# UNITED STATES PATENT AND TRADEMARK OFFICE

APPLICATION NO.	FILING DATE	FIRST NAMED INVENTOR	ATTORNEY DOCKET NO.	CONFIRMATION NO.
10/622,751	07/18/2003	Matthew David Tarler	CMD-006	3135

## Final Rejection

Fig. 6B

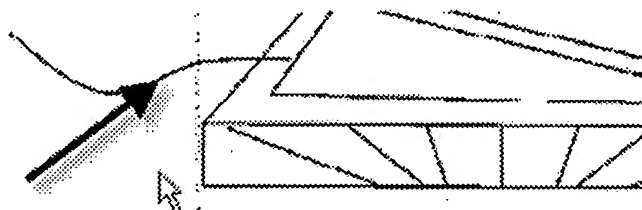
3. The drawings are objected to because all the elements in the figures are not labeled. For example,

Corrected drawing sheets in compliance with 37 CFR 1.121(d) are required in reply to the Office action to avoid abandonment of the application. Any amended replacement drawing sheet should include all of the figures appearing on the immediate prior version of the sheet, even if only one figure is being amended. The figure or figure number of an amended drawing should not be labeled as "amended." If a drawing figure is to be canceled, the appropriate figure must be removed from the replacement sheet, and where necessary, the remaining figures must be renumbered and appropriate changes made to the brief description of the several views of the drawings for consistency. Additional replacement sheets may be necessary to show the renumbering of the
